IREDELL COUNTY HEALTH DEPARTMENT

IMPROVEMENT PERMIT / AUTHORIZATION TO CONSTRUCT / OPERATION PERMIT / EXISTING SYSTEM INSPECTION

PERMIT# 141535 PIN# 4638530052

ADDRESS 830 Big Indian Loop Mooresville, NC 28117

AS BUILT SKETCH

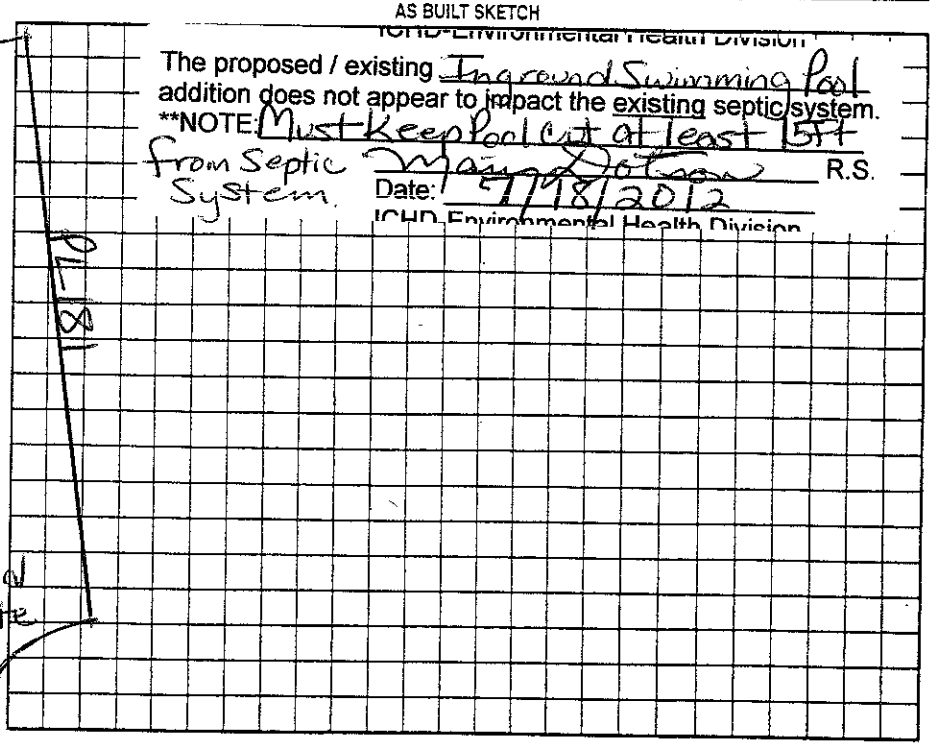
Comments/Conditions: Note: Must Keep Pool "cut" at least 15Ft from Septic System. ☆ Per Builder will not be cutting house site. 18'x36'

The proposed / existing Inground Swimming Pool addition does not appear to impact the existing septic system.

**NOTE: Must Keep Pool cut at least 15ft from Septic System.
